Well Name: WF FEDERAL 25	Well Location: T30N / R14W / SEC 25 / SESE / 36.779918 / -108.256794	County or Parish/State: SAN JUAN / NM
Well Number: 2	Type of Well: CONVENTIONAL GAS WELL	Allottee or Tribe Name:
Lease Number: NMNM0207001	Unit or CA Name:	Unit or CA Number:
US Well Number: 3004530713	Well Status: Inactive	Operator: HILCORP ENERGY COMPANY

Type of Submission: Notice of Intent	Type of Action: Plug and Abandonment
Date Sundry Submitted: 01/21/2022	Time Sundry Submitted: 09:14
Date proposed operation will begin: 02/01/2022

## P&A Procedure

**CONDITIONS OF APPROVAL**

## PROPOSED P&amp;A WELLBORE SCHEMATIC

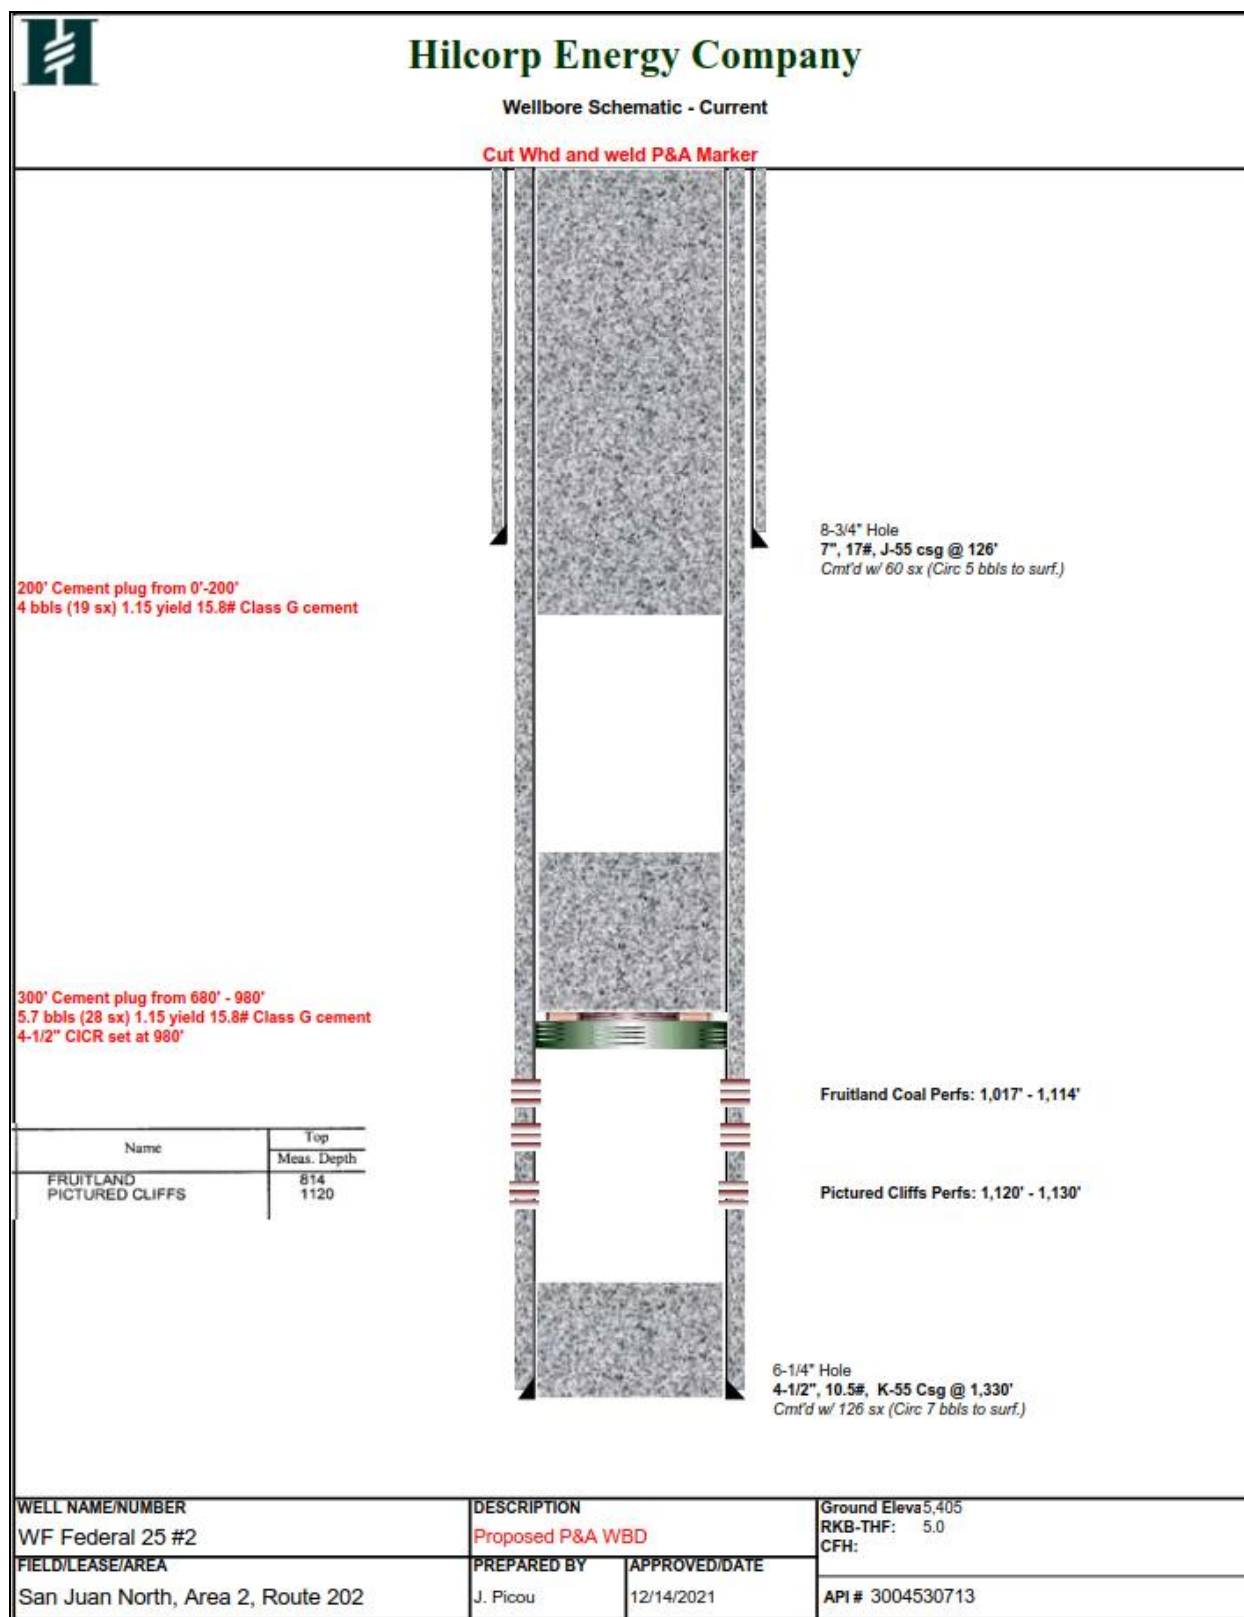
1. Plugging operations authorized are subject to the attached "General Requirements for Permanent Abandonment of Wells on Federal and Indian Lease."
2. The following modifications to your plugging program are to be made:
  - a) Add a plug, or pump cement below the retainer, to cover the Pictured Cliffs top at 1120 feet.
3. Farmington Office is to be notified at least 24 hours before the plugging operations commence at (505) 564-7750.

- Add a plug, or pump cement below the retainer, to cover the Pictured Cliffs top at 1120'.
